October 24, 2012

RE: Draft Comprehensive Wastewater Management Plan and Draft Environmental Impact Report, and Notice of Project Change: Little Pond, Great Pond, Green Pond, Bournes Pond, Eel Pond, and Waquoit Bay Watersheds and Recommendations for West Falmouth Harbor Watershed

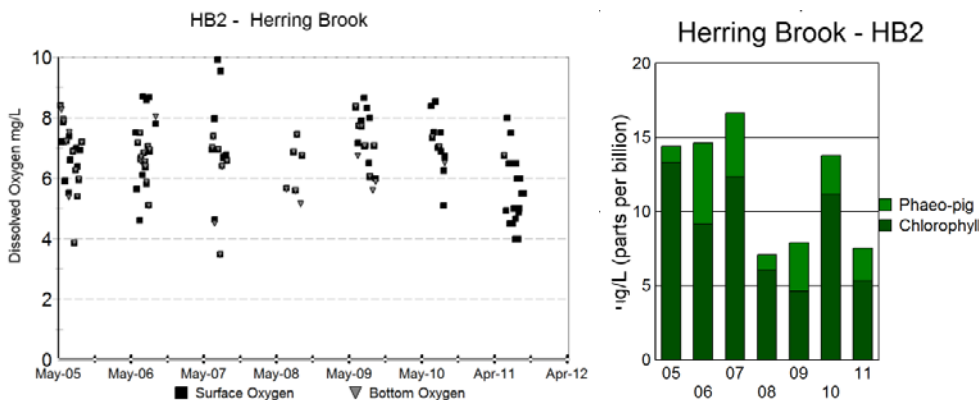
In a letter dated December 19, 2011, the Coalition provided comments to the Town of Falmouth on the GHD Technical Memorandum No. 9 (Tech Memo 9), which considers the feasibility of Sites 7 and 10 as wastewater recharge sites. The Coalition would like to re-affirm the concerns stated in that letter – that the water quality impacts on receiving waters of discharged effluent from Sites 7 and 10 have not been adequately characterized.

Tech Memo 9 asserts that effluent recharged at Site 7 will discharge into Herring Brook and Buzzards Bay at Herring Brook and between Herring Brook and West Falmouth Harbor. Effluent recharged at Site 10 will discharge to Wing Pond, West Falmouth Harbor, and Buzzards Bay at Herring Brook and beyond West Falmouth Harbor (Tech Memo 9). Each of these water bodies is sensitive to nutrient inputs. **This DCWMP/DEIR will not be a victory for the Town of Falmouth or the environment if water quality improvements in South Coast Ponds are achieved at the cost of water quality degradation in other water bodies.**

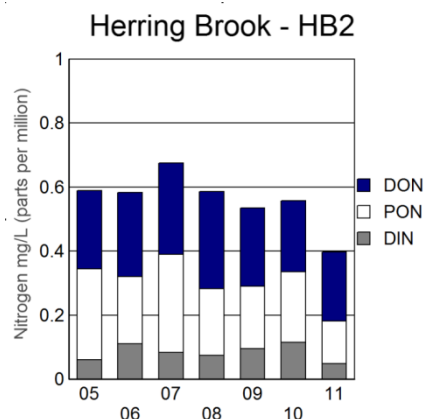
In the absence of an MEP report for Herring Brook to determine what an appropriate concentration of total nitrogen is, we look to similarly situated estuarine habitats for guidance. The Massachusetts Estuaries Project calculated a threshold nitrogen concentration for Mashapaquit Creek in West Falmouth Harbor at 0.412 mg/L. *Massachusetts Estuaries Project Linked Watershed-Embayment Model to Determine Critical Nitrogen Loading Thresholds for West Falmouth Harbor, Falmouth, Massachusetts* page 136.

Coalition data illustrate nitrogen concentrations at the mouth of Herring Brook which exceed those concentrations found by the MEP to be protective of water quality in neighboring salt marsh environments indicating an impaired water body unable to assimilate any new source of nitrogen. Importing a new nitrogen load from outside the Herring Brook watershed is inappropriate and would contribute to a violation of state water quality standards.

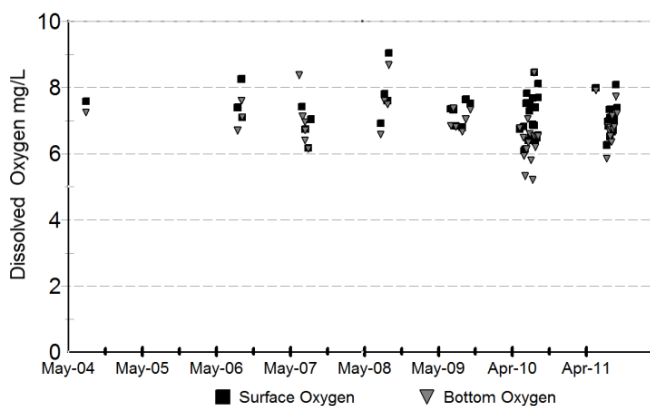
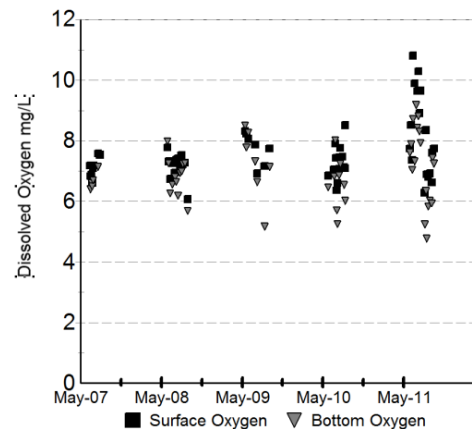
As stated above, class SA waters shall not have a dissolved oxygen level below 6 mg/L, shall have excellent aesthetic value and shall be free from color and turbidity in concentrations that are aesthetically objectionable or would impair the resource. *314 CMR 4.05(4)(a)*. However, dissolved oxygen in central Buzzards Bay is beginning to reach levels below 6mg/L.

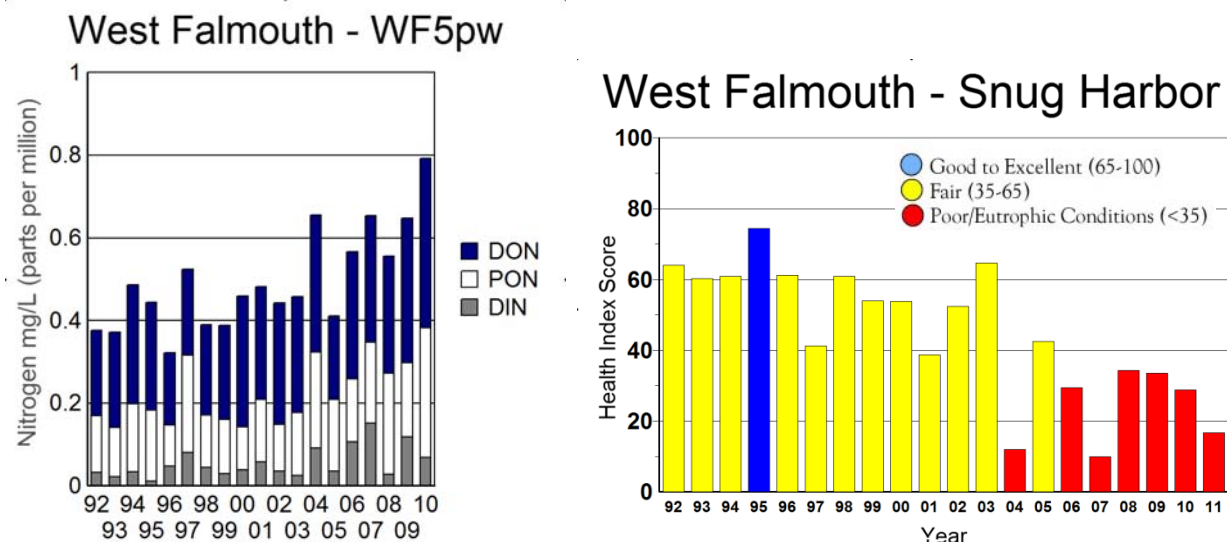
The DCWMP/DEIR proposes that the Blacksmith Shop Road Wastewater Treatment Facility be expanded to a total capacity of 2.1 million gallons per day (mgd). Tech Memo 9 notes that 2.1 mgd is the *additional* amount of wastewater that would be generated from Phase 1 and 2 Areas, which would bring the total flow to approximately 2.6 mgd if all areas in Phase 1 and 2 were sewered. Tech Memo 9 further states that because of Falmouth's seasonal population shifts, "the wastewater flow in summer (maximum month flow) will increase by a factor of 1.8 to approximately 3.8 mgd" and that "the capacity of recharge areas will need to be based on maximum month flow considerations." While the current DCWMP/DEIR seeks to limit the amount of sewerage required with the demonstration of non-traditional wastewater and nitrogen management technologies, sewerage will still be a significant part of Falmouth's wastewater

With the central Bay beginning to show decline in oxygen levels, it does not make sense to increase the nitrogen load to Buzzards Bay by these large volumes. An additional 3.8 mgd of wastewater at 3mg/L total nitrogen has the effect of dumping an additional 35,000lbs of new nitrogen into Buzzards Bay. It is inappropriate to import this amount of nitrogen generated from *outside* the Buzzards Bay basin to Buzzards Bay.
